DETAILED ACTION

3. Claims 1-2 are rejected under 35 U.S.C. 103(a) as being unpatentable over Koike et al. in view of Yoshino et al. (US 5,190,794).

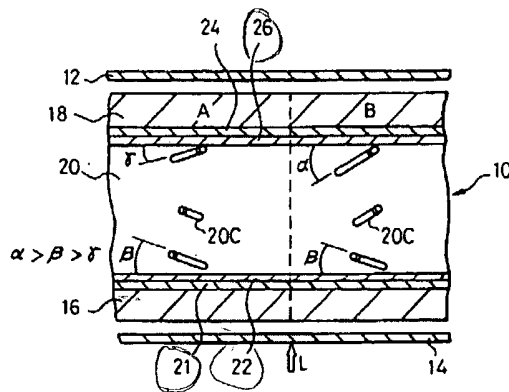
Koike et al. has a liquid crystal display element (panel) comprising: a circuit array substrate 18 having pixel electrodes 24 (connected to an active matrix circuit) (column 11, lines 60-70). Fig. 6 below shows the circuit array substrate 18 (active matrix circuit).

Below in Fig. 4, Koike et al. shows a circuit array substrate 18 having pixel electrodes 24, a counter substrate 16 (column 12, lines 1-2) having a common electrode 21, alignment films 22 and 26 formed on said pixel electrodes 24 and said common electrode 21, and a liquid crystal composition 20 charged in a gap between said circuit array substrate 18 and counter substrate 16 (column 11, lines 50-55).

While Koike et al. teaches that the color filter layer (not shown) is provided under the common electrode 21 (column 11, lines 65-70), Koike et al. also states that it is possible to reverse the common electrode 21 and the pixel (element) electrode 24 (column 12, lines 1-2). Therefore it would have been obvious to one of ordinary skill to have interposed the color filter under the pixel electrode 24 instead of common electrode 21, which places the color filter between the pixel electrode 24 and the circuit array substrate 18.

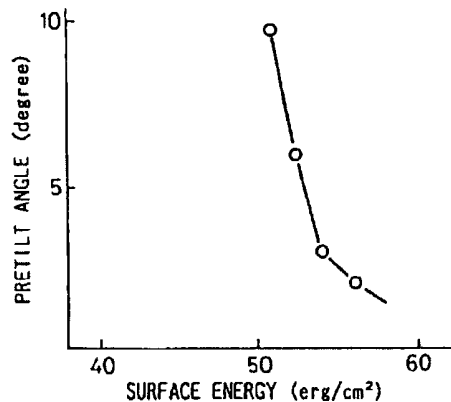
Koike et al. teaches that an increase in surface energy of the alignment films reduces the pretilt angle, and that this is done by taking advantage of UV irradiation of the polyimide film (column 16, lines 1-15). The polyimide film before irradiation has a higher pretilt angle with the corresponding lower surface energy (column 15, lines 55-65). Thus Koike et al. teaches

that low pretilt angle with the corresponding high surface energy for the alignment film is desirable.

The graph of pretilt angle versus surface energy above shows that the area of interest corresponding to the desired low tilt angle is the one with the surface energy of greater than 50 and less than 60 dyn/cm (erg/cm^2) which overlaps the claimed range of 51 to 60 dyn/cm. The prevention of image-sticking phenomenon and white or black turbid spots is the result of the low pretilt angle with the corresponding high surface energy of the alignment layer.
